Standards Governing the Design of Curbside Mailboxes

ACTION: Final rule.

SUMMARY: The Postal Service is replacing USPS STD 7B, which governs the design of curbside mailboxes, with

new USPS STD 7C. The new STD 7C was developed internally to meet the operational requirements of the Postal Service.

TRADITIONAL MAILBOX
 FIGURE 1A

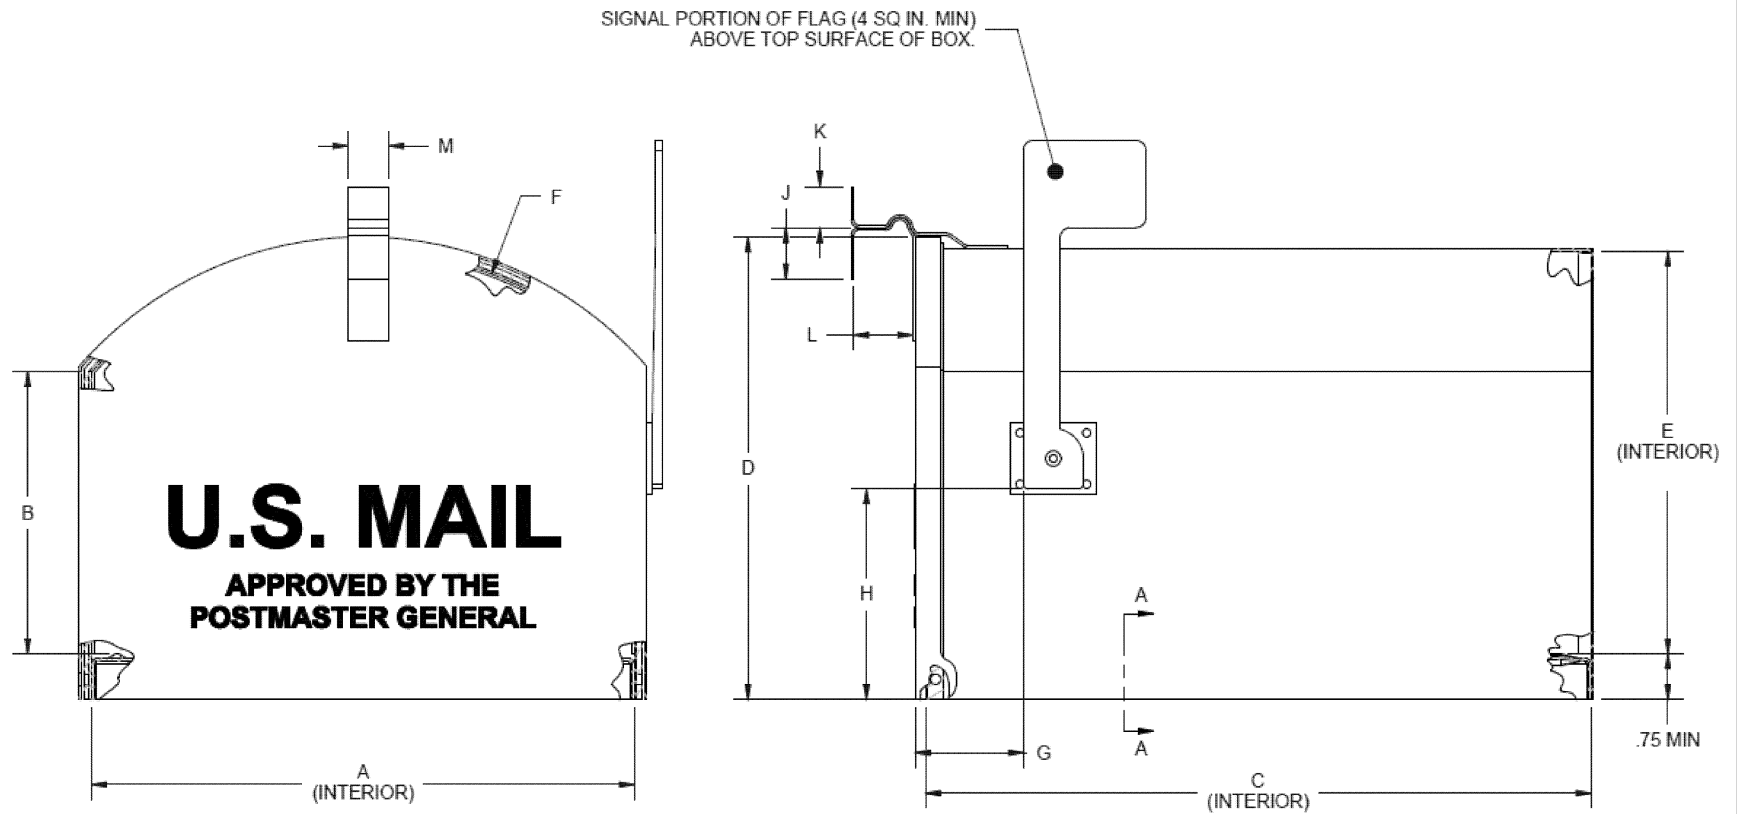
These comments also suggested the need for clarification of the requirements concerning the flag dimension for traditional mailboxes in Figure 1A, and more specificity regarding the requirement in section 3.9 that the color of the flag present a “clear contrast” with the predominant color of the mailbox. These suggestions were not accepted. We believe that such changes to longstanding requirements for boxes already approved under former STD 7B would not be appropriate in this context.

**LOCKED MAILBOX- MAIL SLOT DESIGN
(FULL SERVICE)
FIGURE 2A**

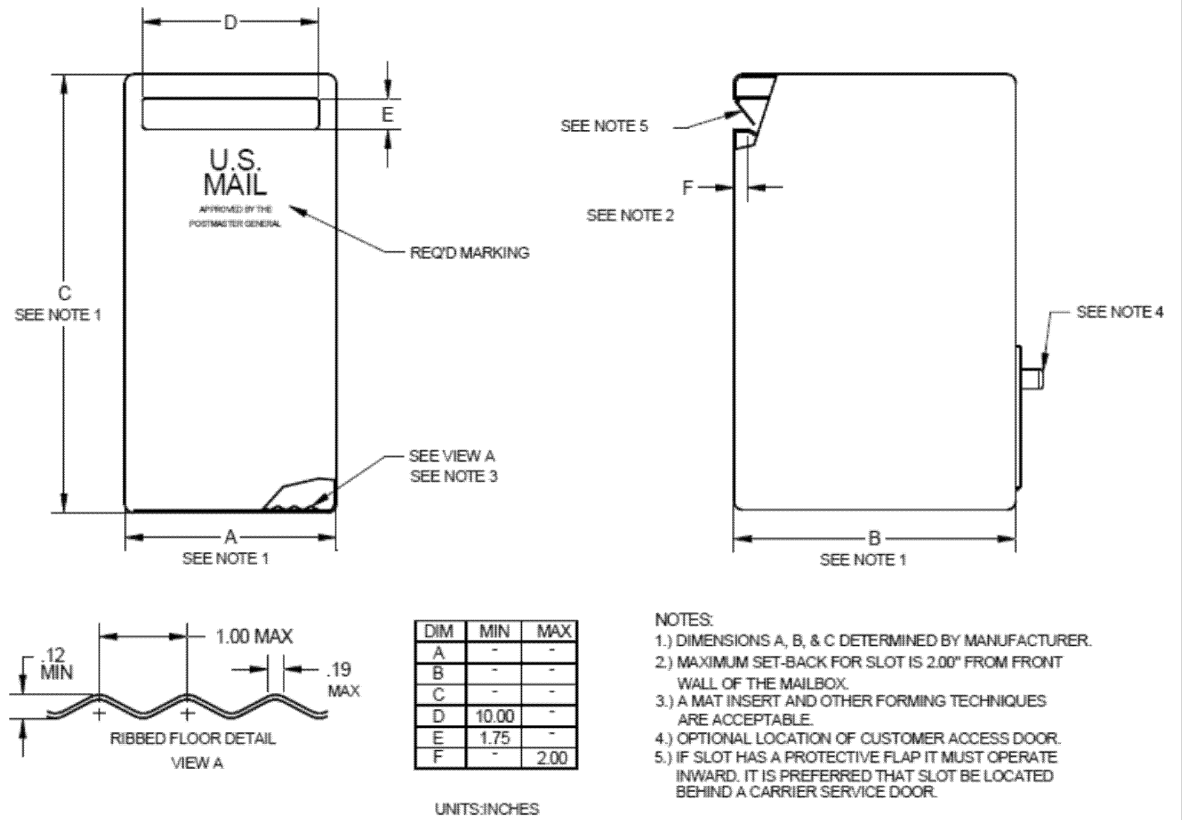
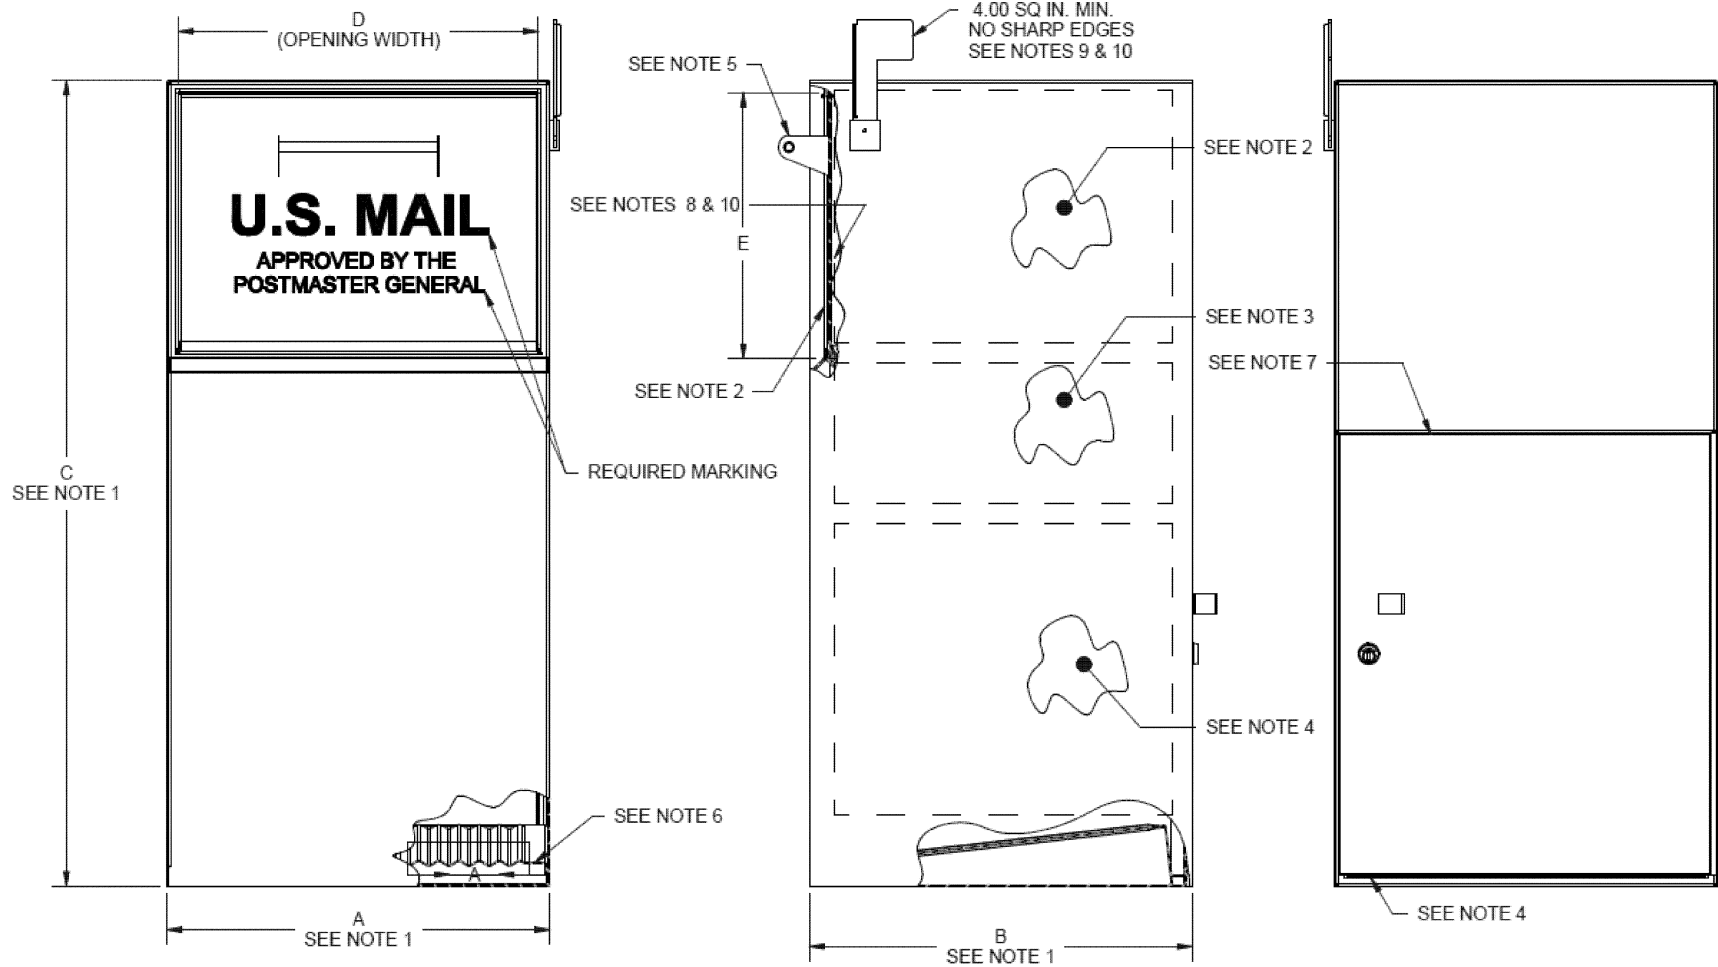
These comments further questioned the requirement in section 3.1.2.1 that the slot for a locked mailbox measure at least 1.75 inches high by 10 inches wide, suggesting that other shapes (such as a modified trapezoid) that allowed the insertion of the test gauges should be acceptable. This change was not accepted. We believe that the dimensions as proposed will facilitate the delivery of mail to the new boxes by simplifying the carrier’s task.

HANDLE/KNOB DESIGNS
FIGURE 5

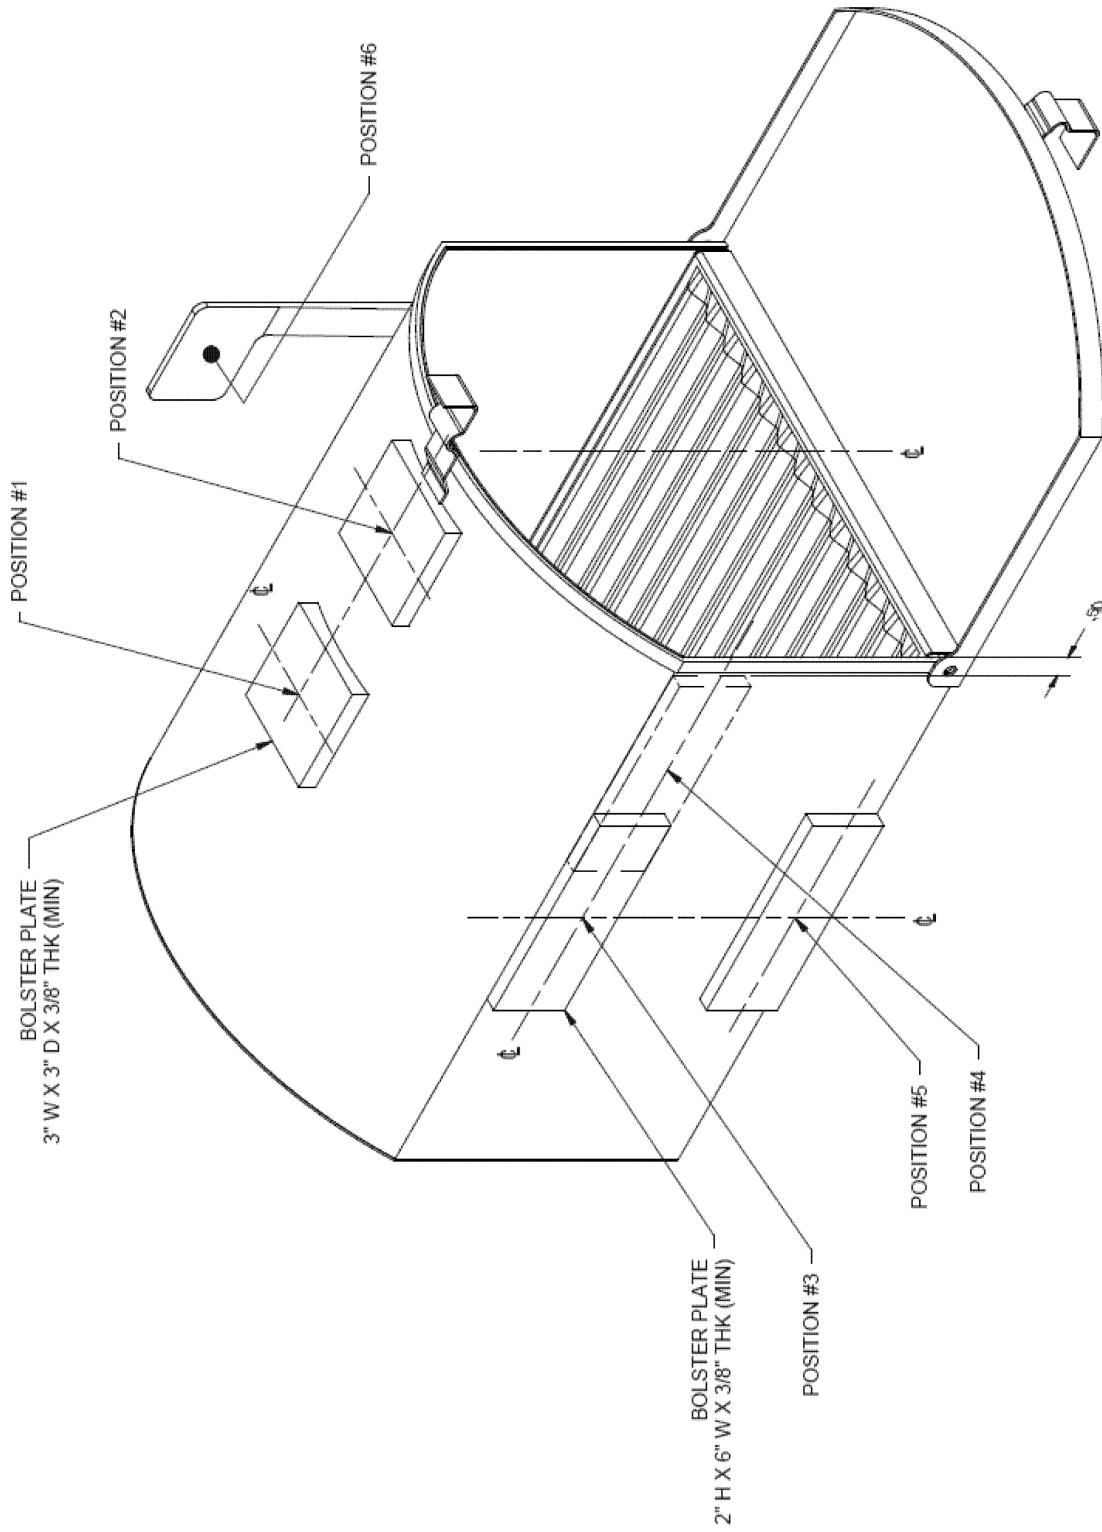
This set of comments also questioned the width of the mailbox door handles

shown in design Figure 5 of the proposed standards, and suggested that they reflected a change from the current standards of USPS STD 7B. No such dimensional changes were intended, and Figure 5 has been reworked accordingly.
